SOUTH FIRST STREET (DRAKE) BRIDGE
R.O.W. and Temporary Workspace Requirements
at Palmer Auditorium Site

MEMORANDUM

SUBJECT: South First Street (Drake) Bridge Improvements
Dedication of street right-of-way and approval of
temporary construction easements

ATTACHMENT A - Proposed Right-of-Way and Temporary Easements

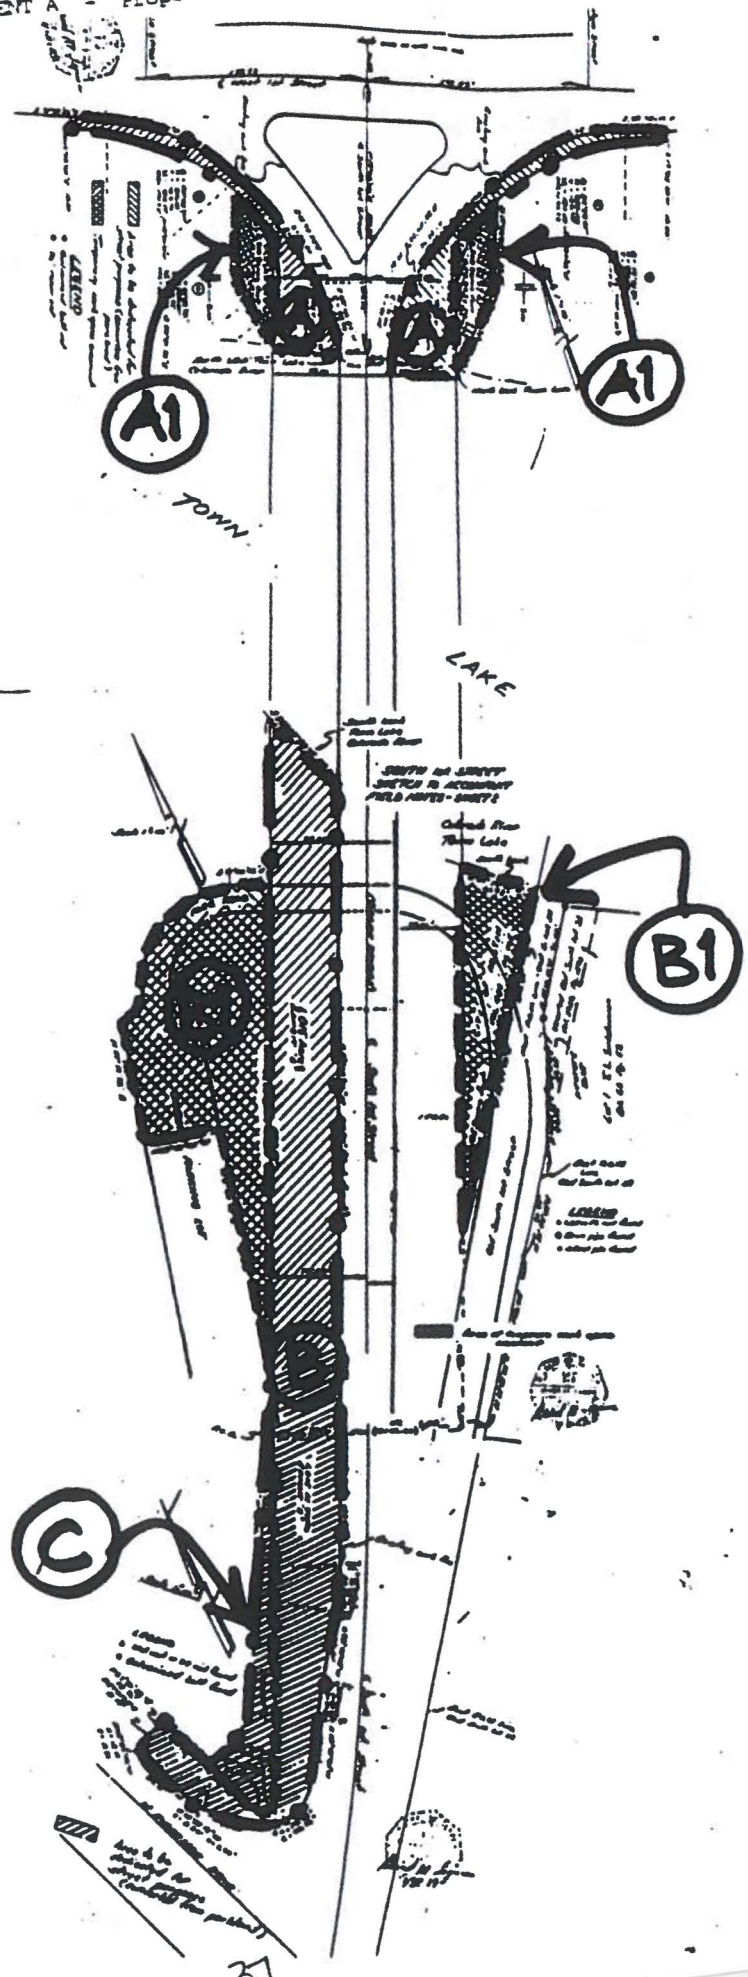
North Bank Town Lake, areas marked A on the attached drawings and metes and bounds descriptions.
Auditorium Shores, areas marked B and C on the attached drawings and metes and bounds descriptions.

The temporary construction easements marked A1, B1 and B2 on the attached plans are necessary to allow the bridge construction and provide a contractors staging area.

1. Dedication of existing parkland as street right-of-way
 - a. North Bank Town Lake
 - Tract 1 6,521 square feet, 0.150 acres
 - Tract 2 6,168 square feet, 0.142 acres
 - As described in the attached metes and bounds description and sketch marked A.
 - b. Auditorium Shores
 - Area B 44,213 square feet, 1.015 acres
 - Area C 5,546 square feet, 0.127 acres
 - As described in the attached metes and bounds descriptions and sketches marked B and C.
2. Approval of temporary construction easements.
 - a. North Bank Town Lake
 - Tract 1 2,560 square feet, 0.059 acres
 - Tract 2 2,310 square feet, 0.053 acres
 - indicated as areas A1 on the attached drawings.
 - b. Auditorium Shores
 - 9,602 square feet, 0.45 acres
 - indicated as area B1 on the attached drawings
 - c. Town Lake South Bank
 - 9,165 square feet, 0.210 acres
 - indicated as area B2 on the attached drawings

1. The requirements of the "Construction in Parks Guidelines", as amended, produced by the Parks and Recreation Department be complied with.
2. The provisions of Ordinance 890126-P Section 13-2-700.2 regulating improvements in public rights-of-way abutting the Waterfront Overlay District or included in the Town Lake Park Plan be complied with.
3. The temporary construction easements adjacent to parkland shall be

fenced entirely with an 8 feet high chain link fence.

4. Replacement tree planting for those trees removed in existing parkland shall be provided, equivalent to 1595 square inches. All other trees shall be protected in accordance with the City of Austin Environmental Criteria Manual.

BURKS DOCK

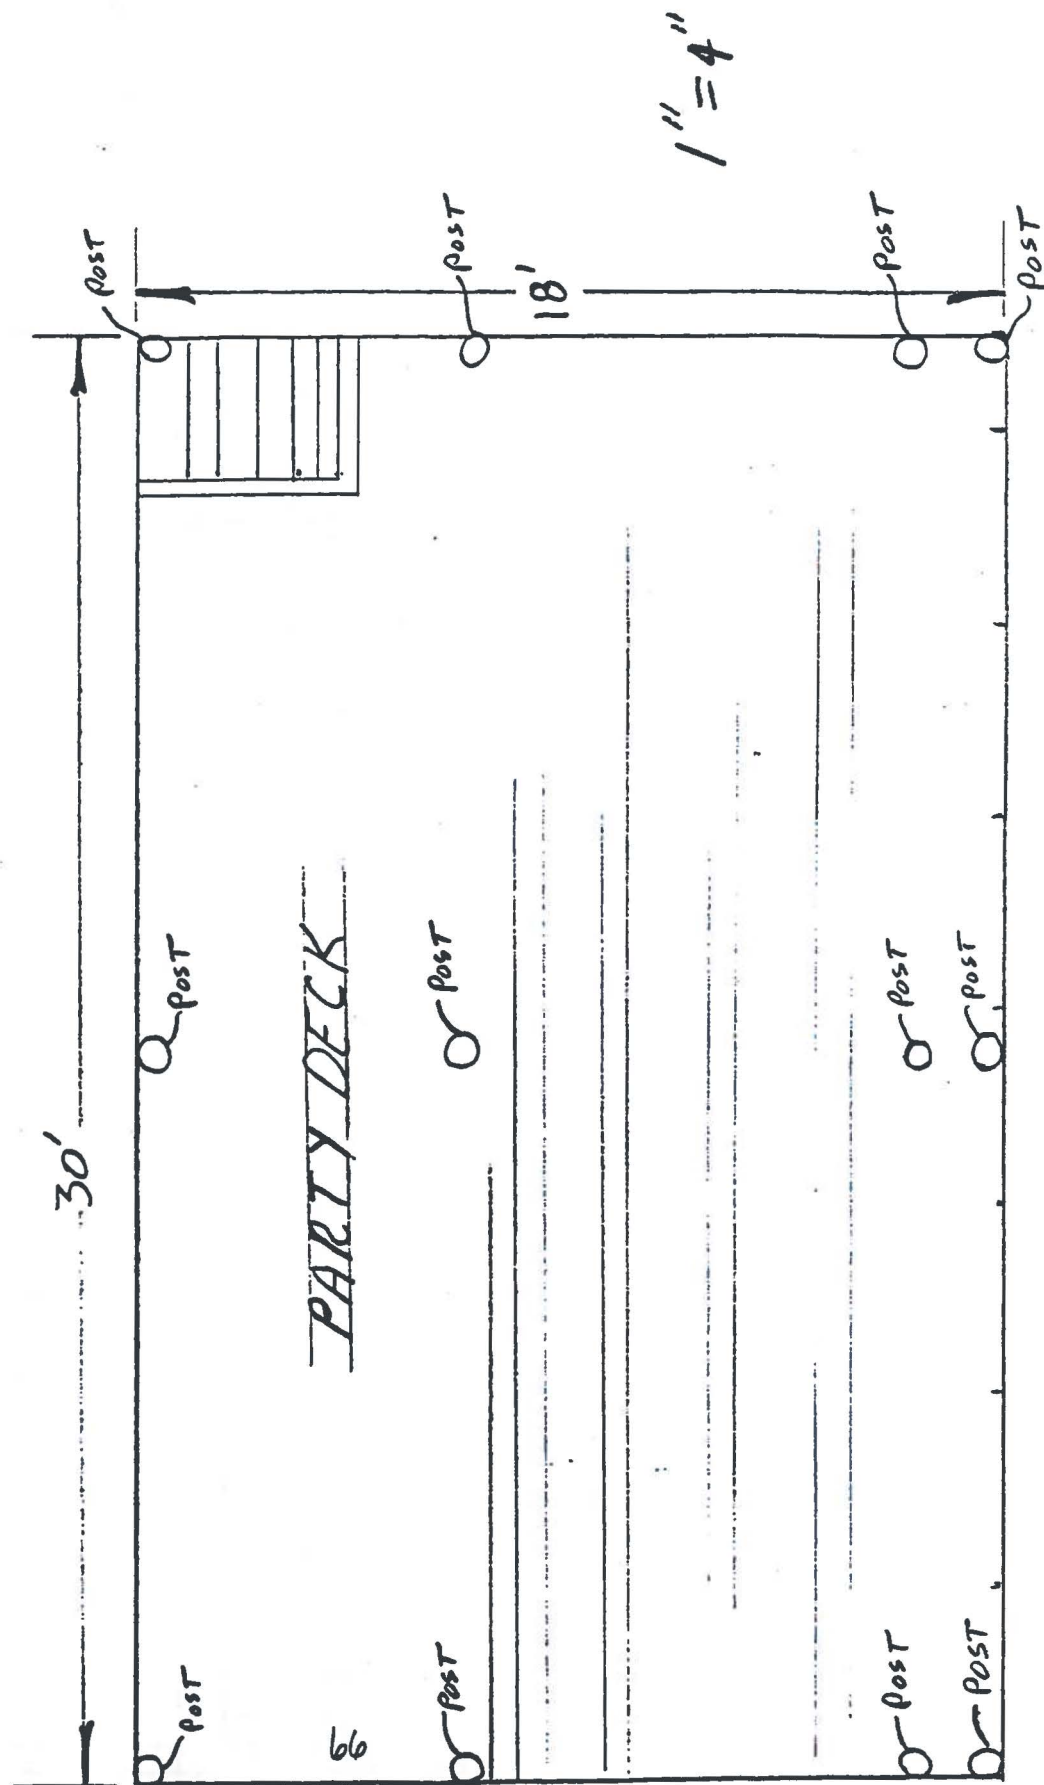
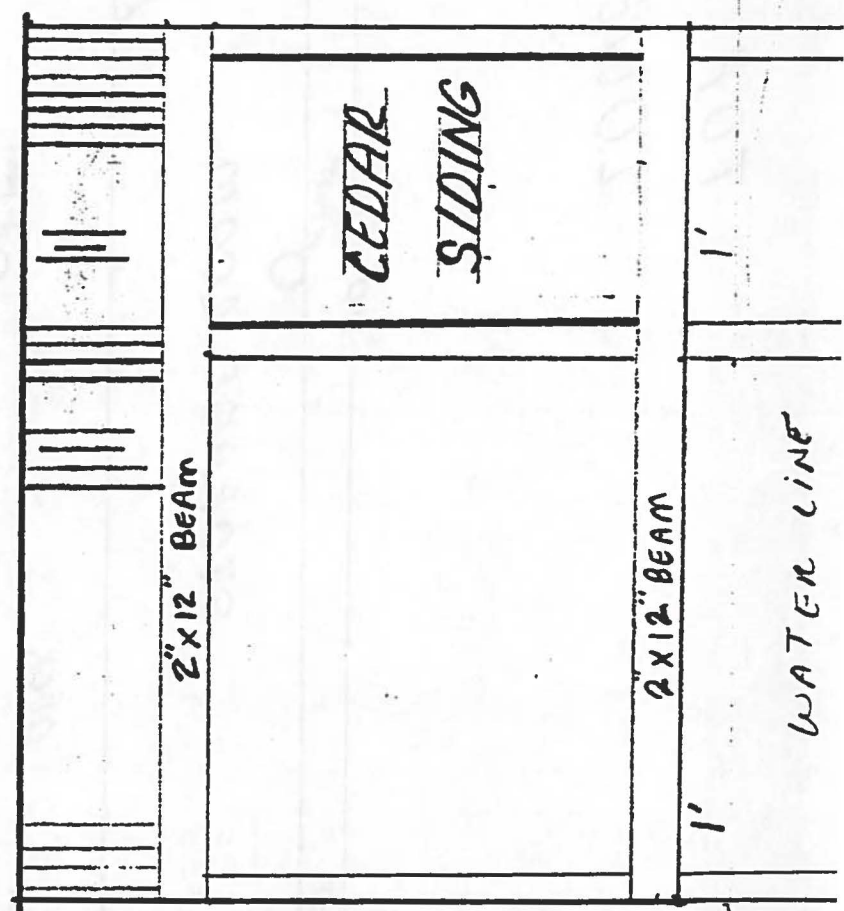
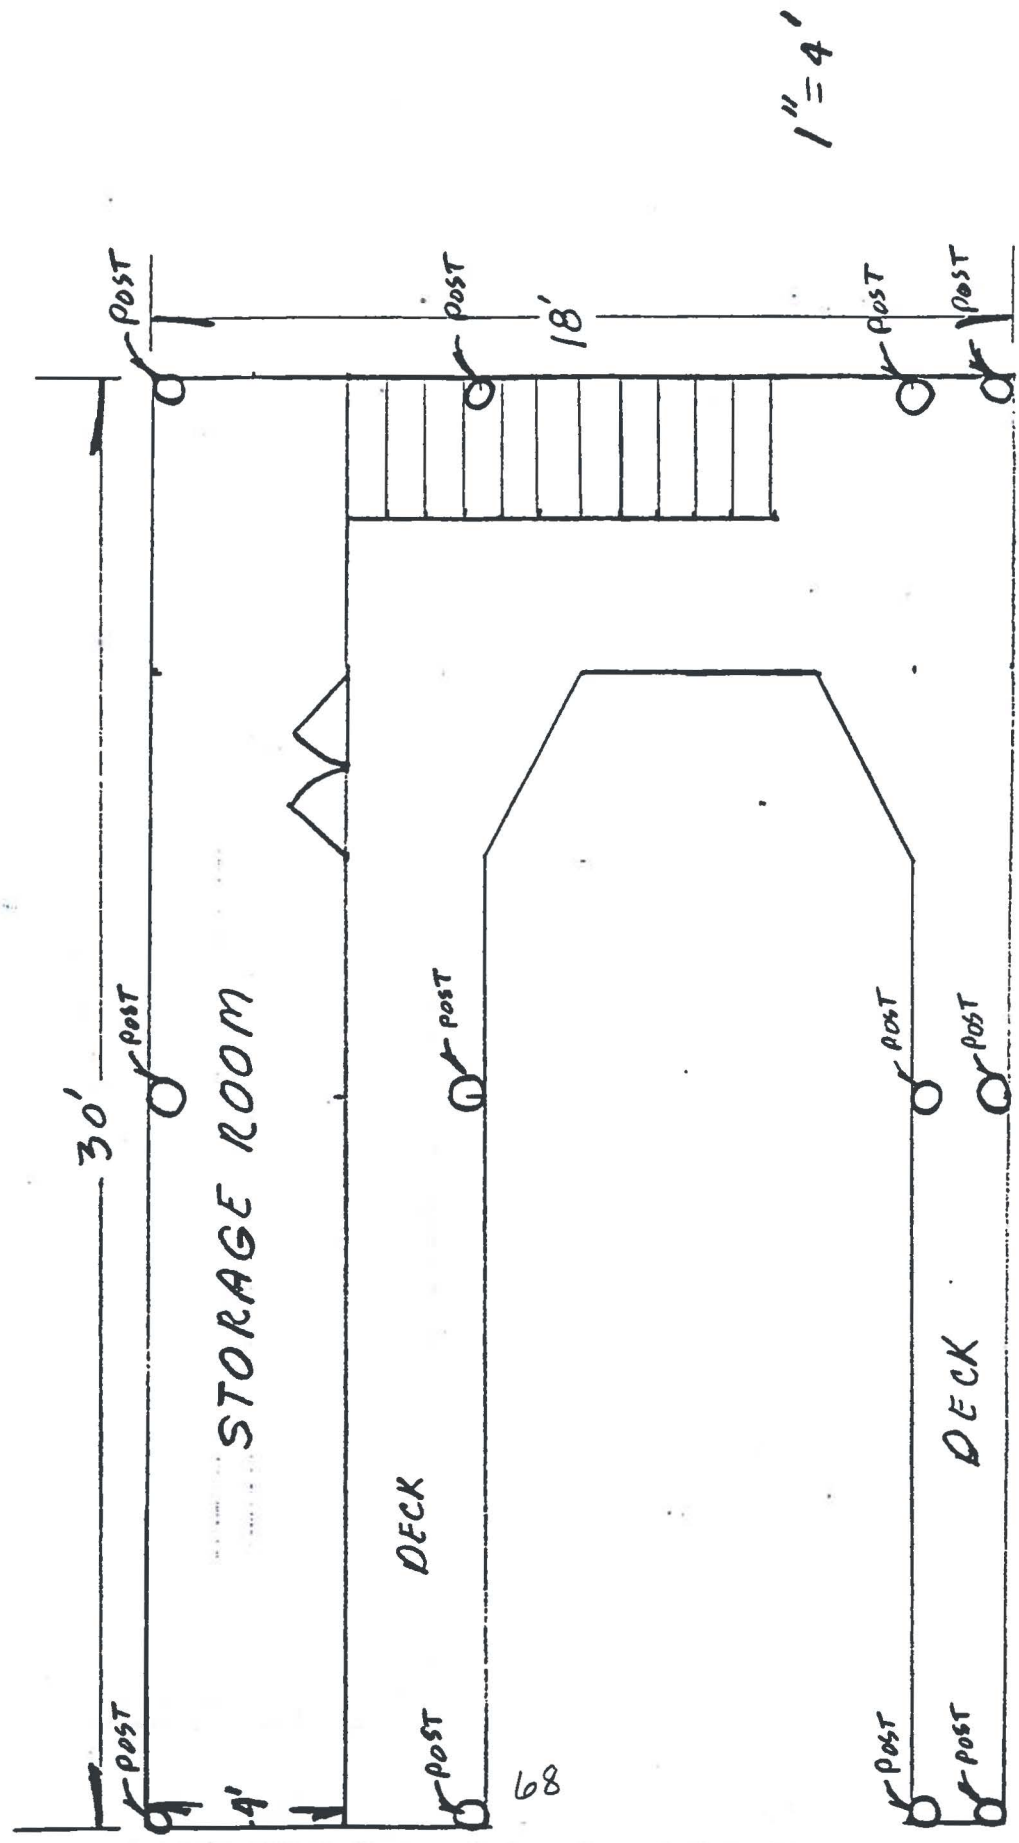
The letter of request indicates that the dock will be 35' long; however, the actual length the dock will extend from the shoreline will be 30'. The additional 5' will be a walkway from the shore to the dock.

The proposed dock includes construction of a deck with a storage room underneath. The proposed location of this storage room is along the complete length of one side of the dock. I feel that this will create a navigation hazard as visibility through the dock will be obstructed. The applicant has agreed to relocate the storage room adjacent to and parallel to the shoreline.

Navigation lights are not indicated on the plan; navigation lights should be provided in accordance with Section 13-2-793.

1. Navigation lights in accordance with Section 13-2-793 of the City Code are provided.

2. The storage room is located adjacent and parallel to the shoreline.
3. The dock extends a maximum of 30' into the water measured from the shoreline.
